TSG-RAN Meeting #10
Bangkok, Thailand, 6 - 8 December 2000

Title: Agreed CRs to TR 25.925

25.925 CR 004r1

Subject: Correction of ANSI-41 Cell Broadcast Service

Figure 6.2: General Protocol Architecture when RNS is connected to ANSI-41 Core Network

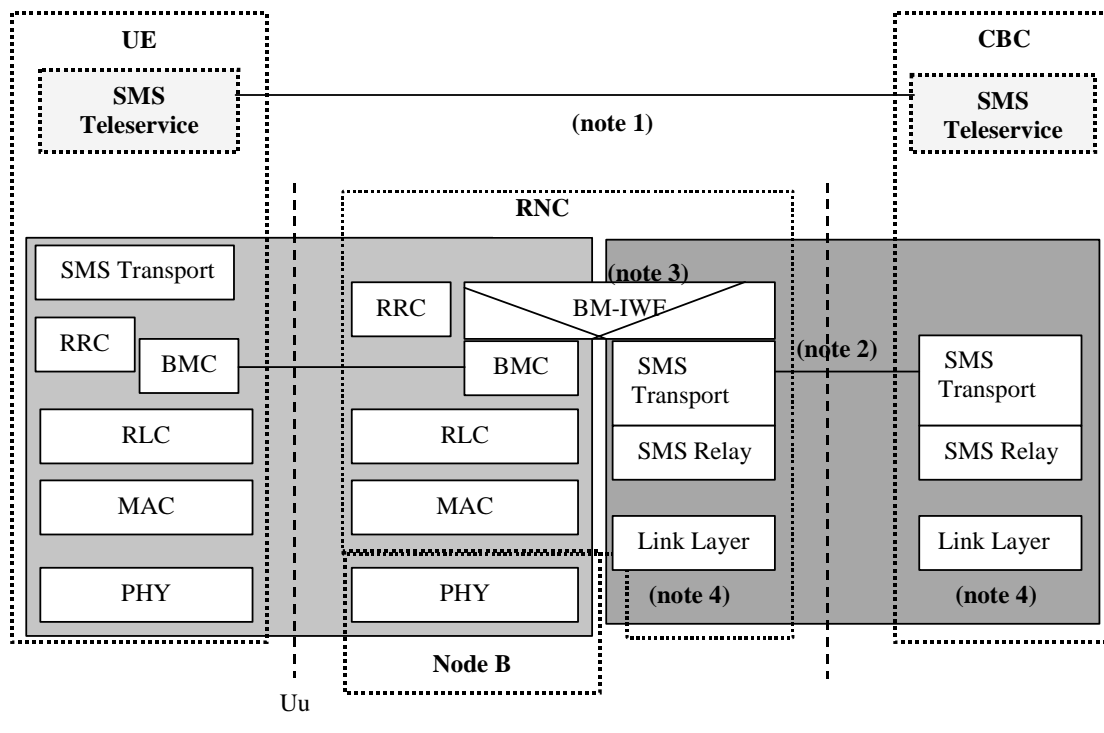
Corrections are necessary to support the ANSI-41 Cell Broadcast Service:

- Description of the ANSI-41 network architecture
- Introduction of a new BMC message type "CBS41 message"
- Description of the scheduling of such messages

Figure 6.2 summarises the network and protocol architecture chosen for Release 1999 by S2, T2, R3, R2 and 3GPP2.
